PUBLIC UTILITIES COMMISSION

RE: Sycamore- Peñasquitos 230-kV Transmission Line Project— Review of Minor Project Refinement #6 Request

Exhibit 1: MPR #6 Maps

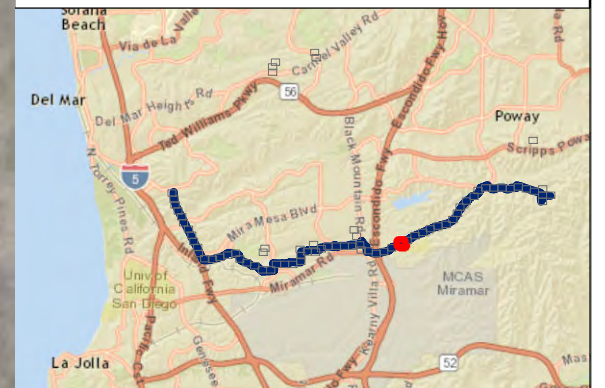
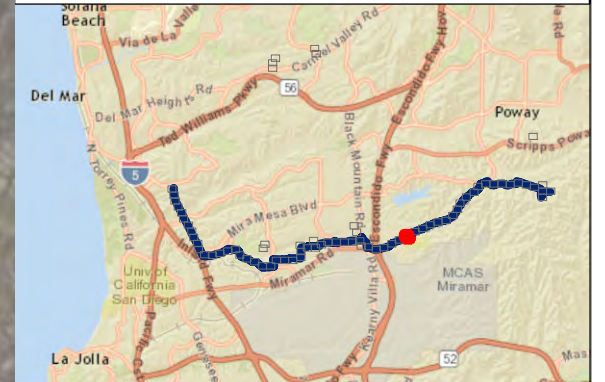
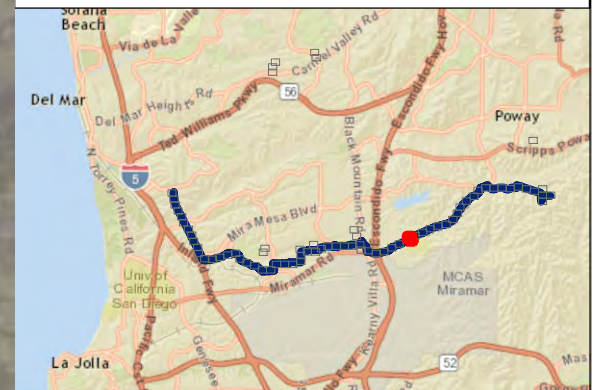
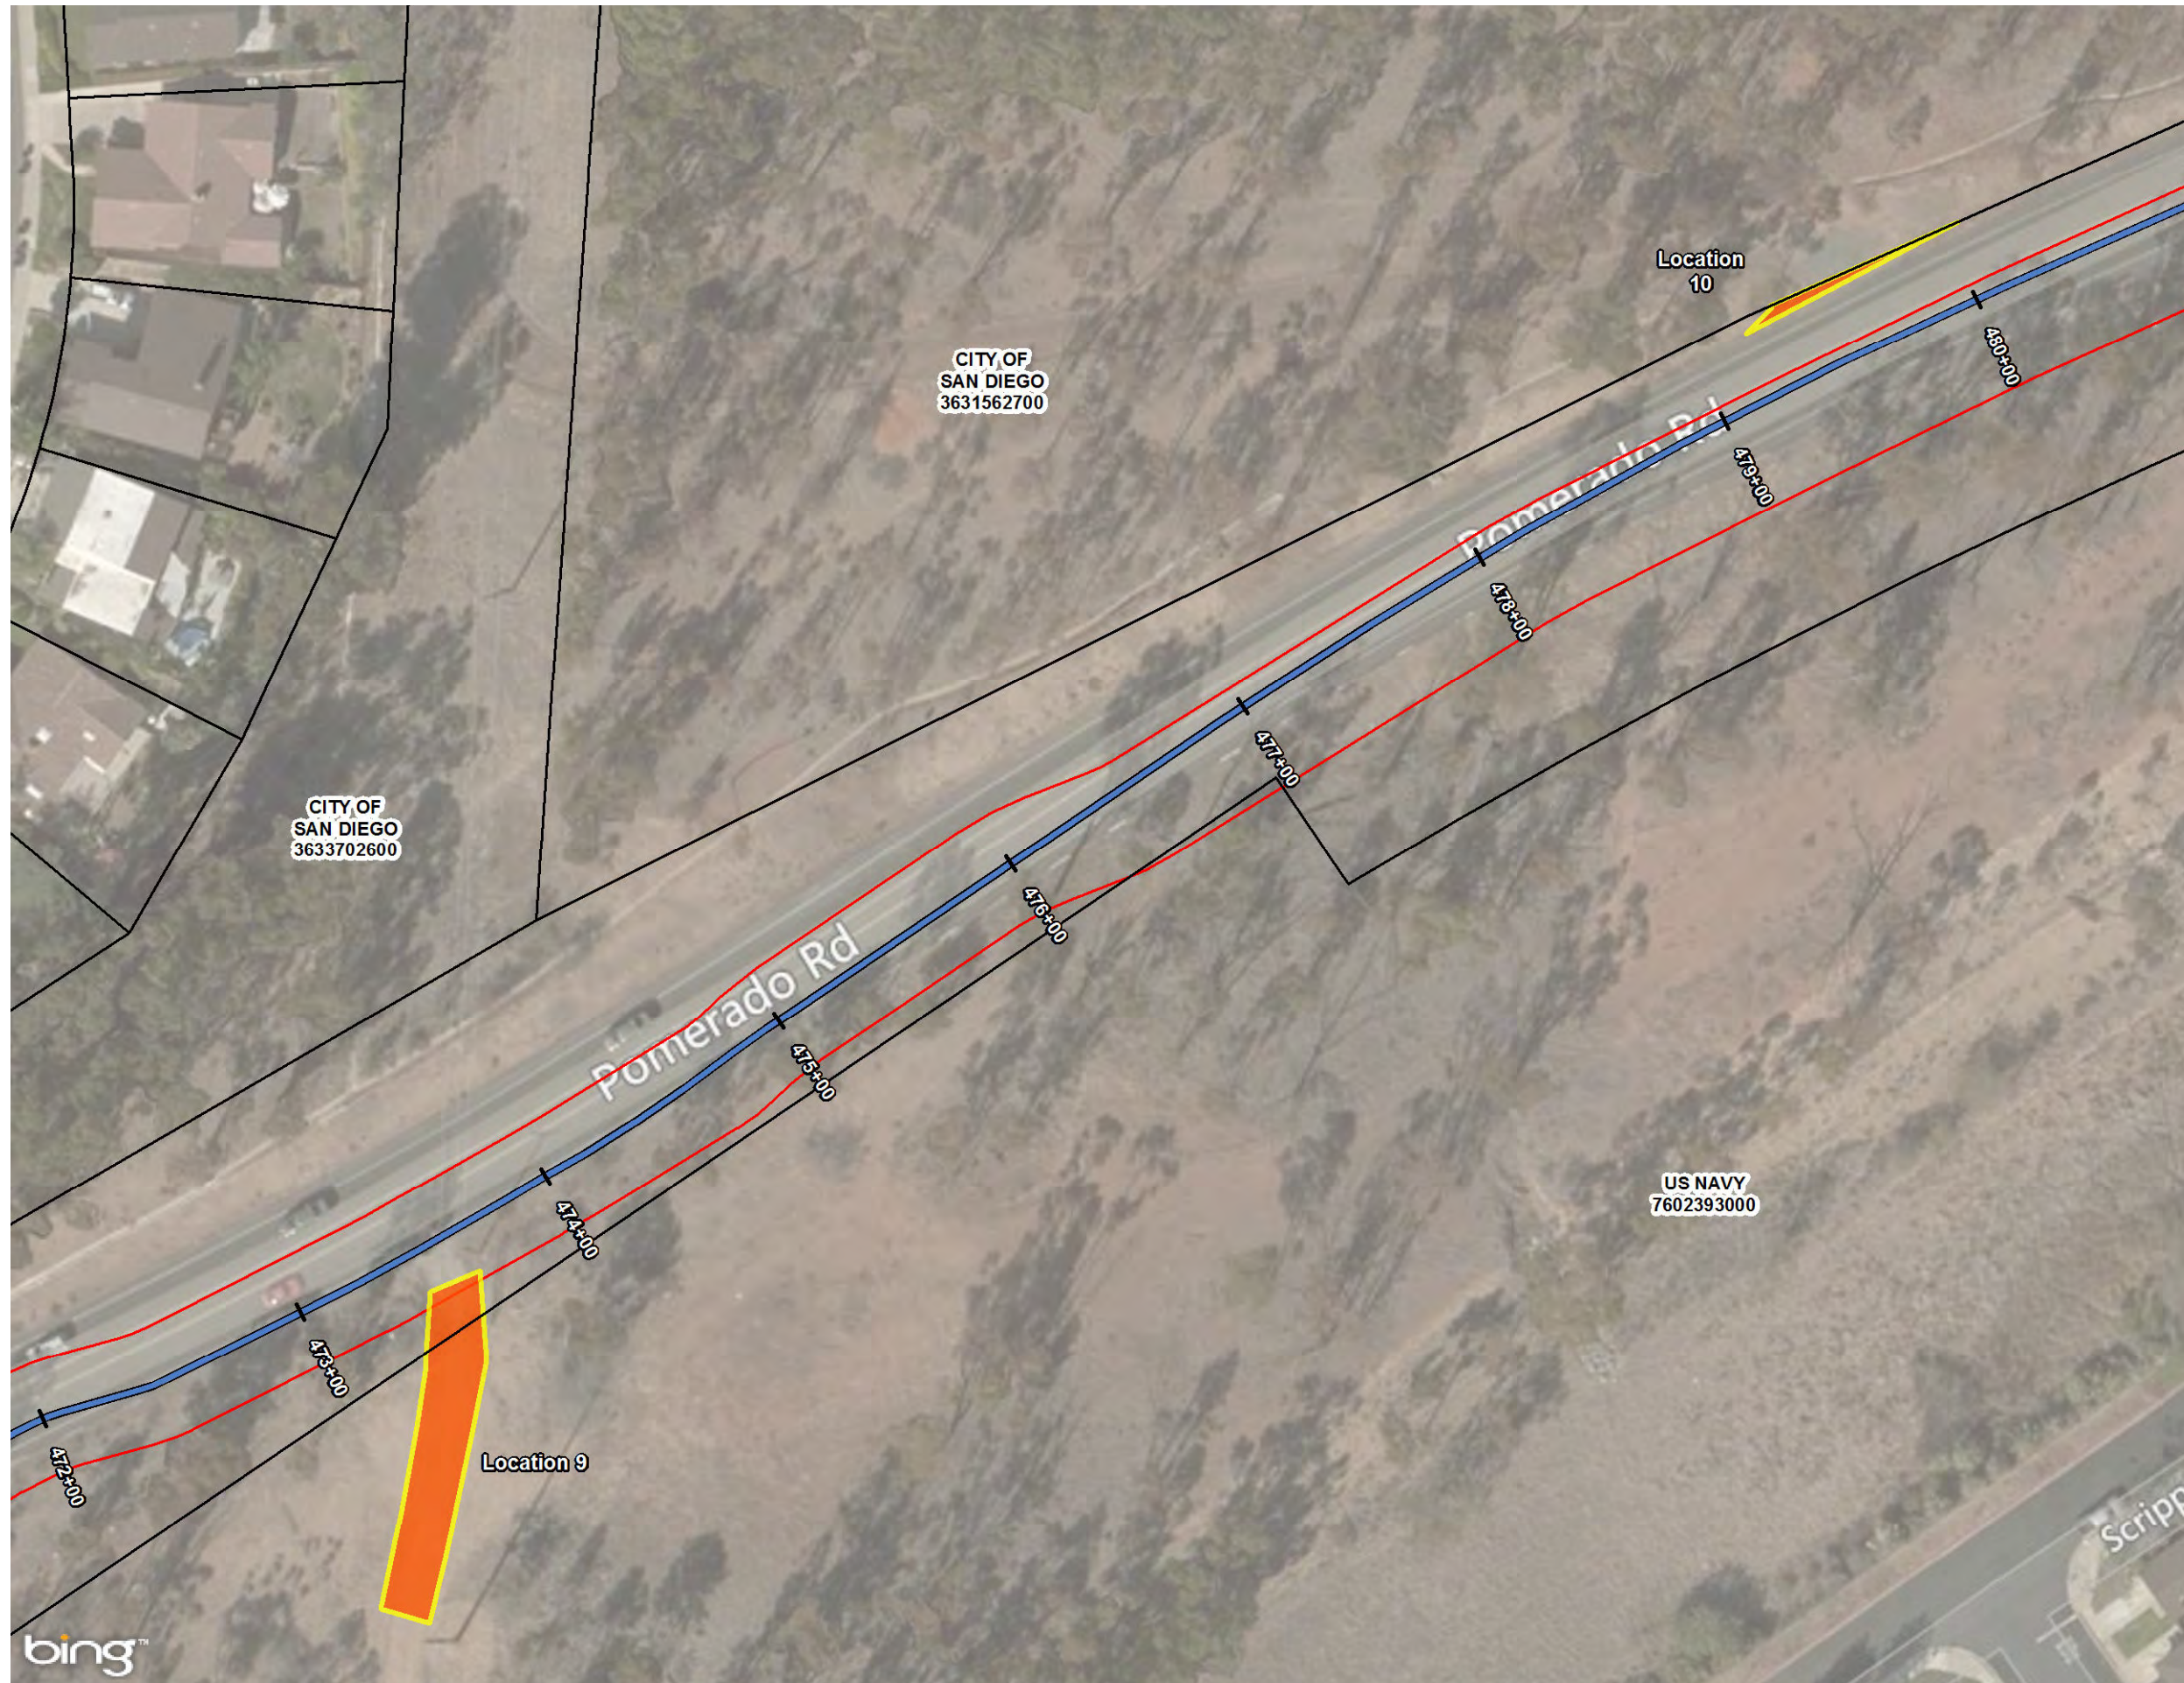
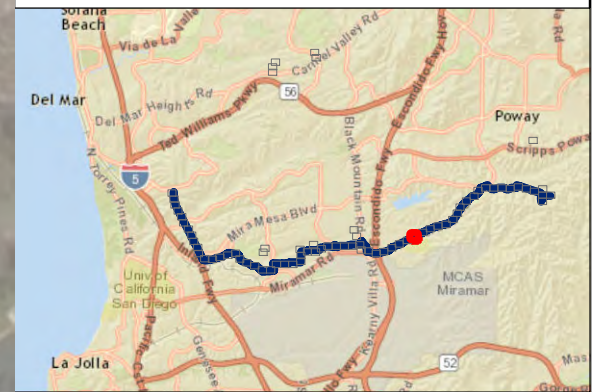
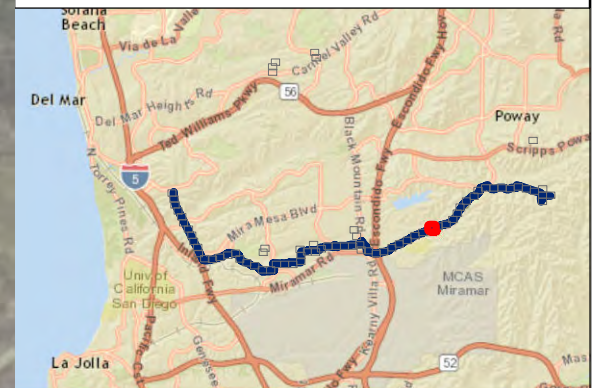
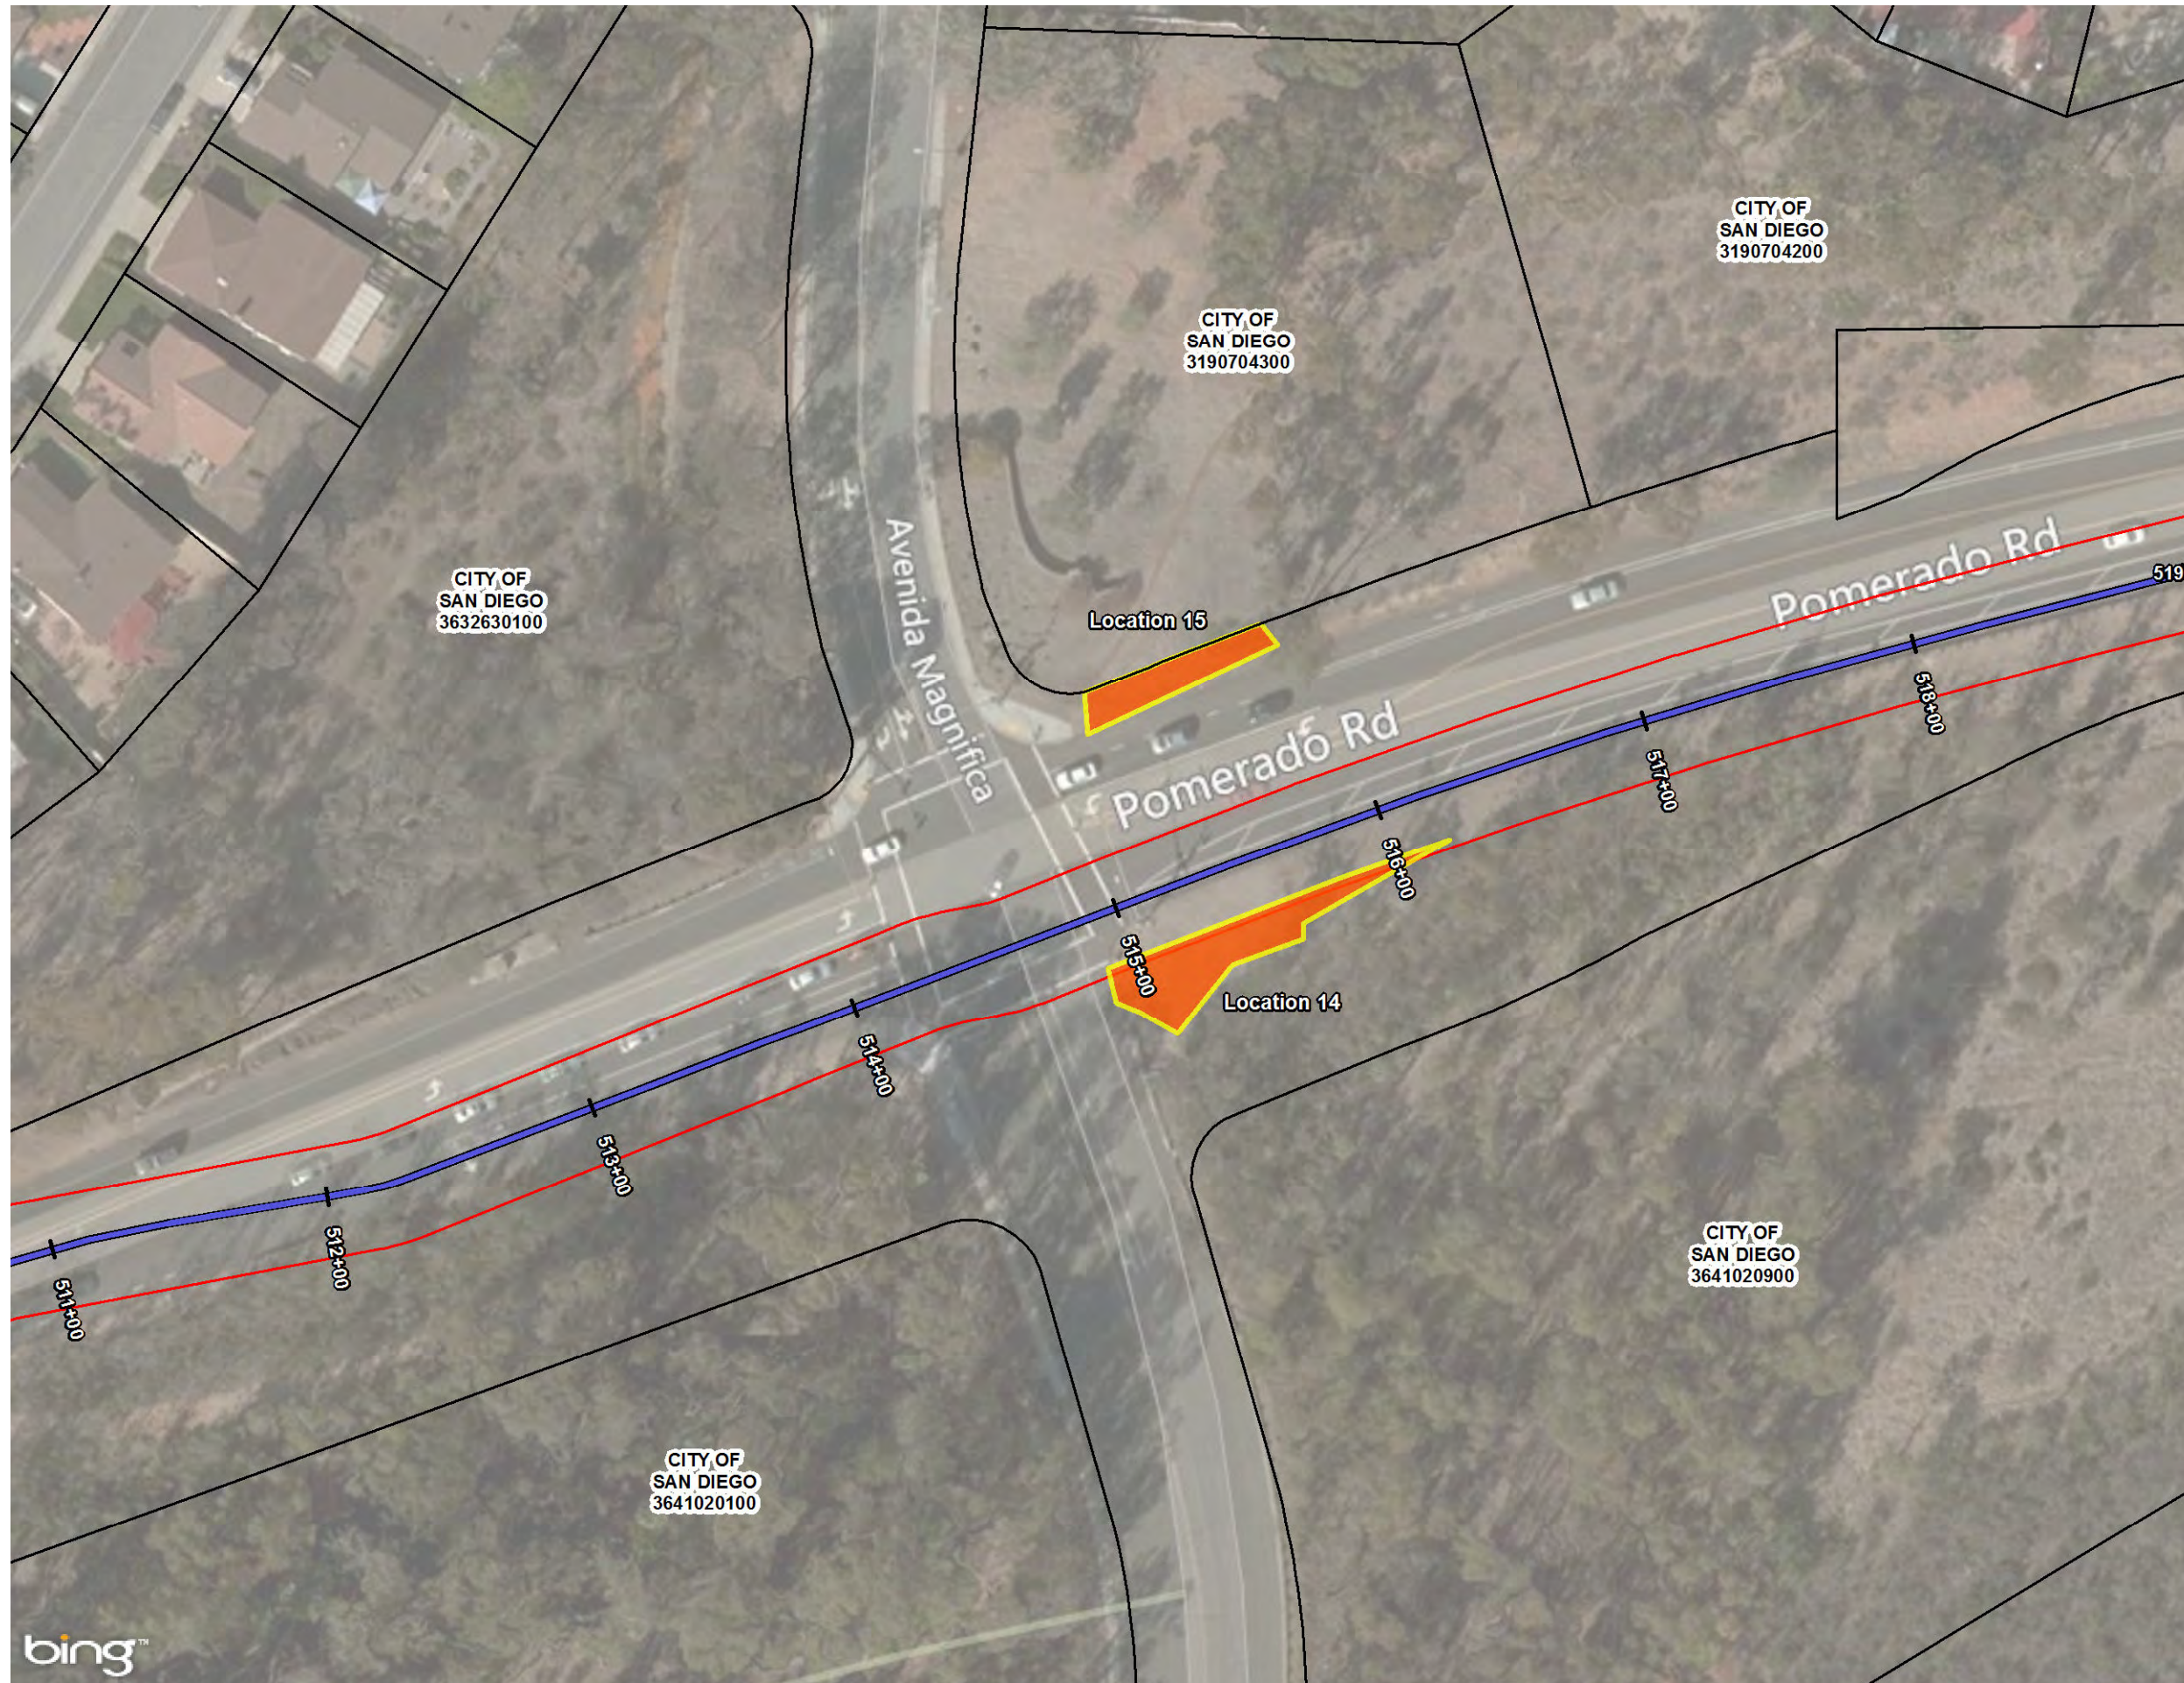
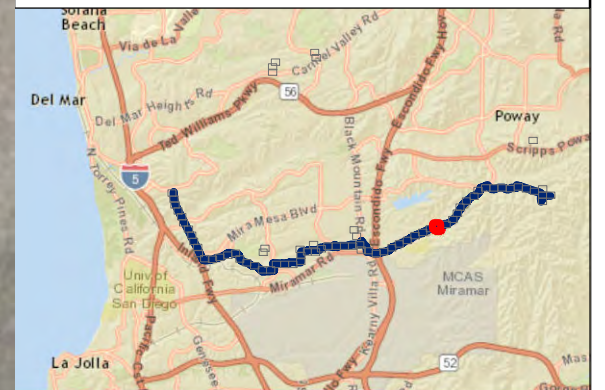
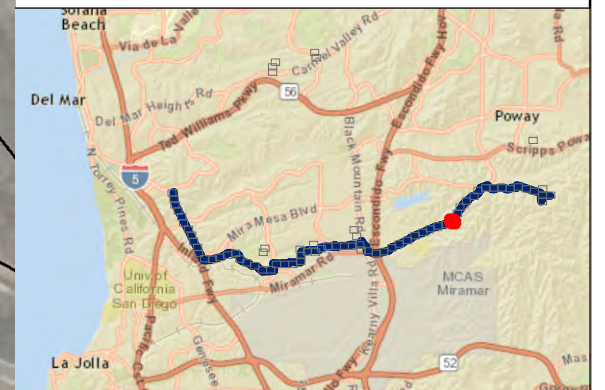
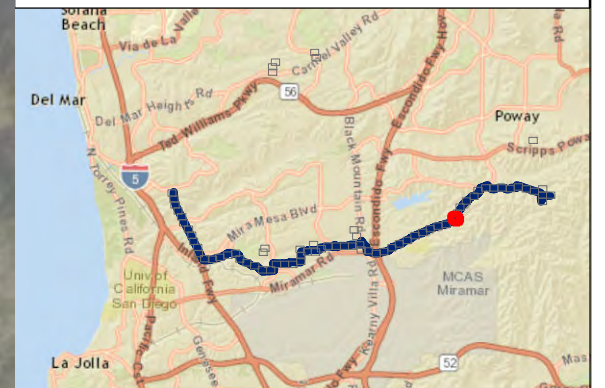
On August 3, 2017, SDG&E submitted Minor Project Refinement (MPR) #6 for approval by the California Public Utilities Commission (CPUC) for the Sycamore-Peñasquitos 230-kV Transmission Line Project (Project). MPR #6 establishes staging yards along the southern and northern perimeters of Pomerado Road, which are shown in Exhibit 1 (attached).

Under this proposed Minor Project Refinement (proposed refinement), SDG&E seeks to add additional temporary work space (as identified above and in Attachment 1), totaling approximately 0.72 acres, along the northern and southern perimeters of Pomerado Road. The use of these areas would not result in any new impacts or increase the severity of a previously analyzed impact as identified in the Project's FEIR and as authorized by Notice to Proceed (NTP) #2 issued by the CPUC on February 7, 2017. No ground disturbing activities are proposed; however, minor vegetation clearing and trimming is proposed (brush, weed, and non-native grasses) as needed to minimize potential fire risk.

The proposed refinement areas along Pomerado Road (Locations 5-17) would be used to stage excavators, backhoes, steel plates, traffic control materials, vaults, pickups and any additional construction related materials and equipment. The proposed refinement areas along Pomerado Road are needed due to space limitations within the approved temporary work space and are necessary to fully clear the roadway for traffic after construction operations cease for the day.

MPR #6 is approved by the CPUC with conditions. The conditions presented below shall be met by SDG&E and its contractors:

1. All applicable Project MMs, APMs, compliance plans, and permit conditions shall be implemented. Some measures have on-going/time-sensitive requirements and shall be implemented prior to and during construction, where applicable. Prior to construction, SDG&E must submit all applicable permits to the CPUC.

12. All staging areas will be clearly delineated with lathe and flagging to ensure construction personnel stay within approved project limits. Portions of staging areas and workspace that support native vegetation will be flagged for avoidance prior to use of the staging areas.
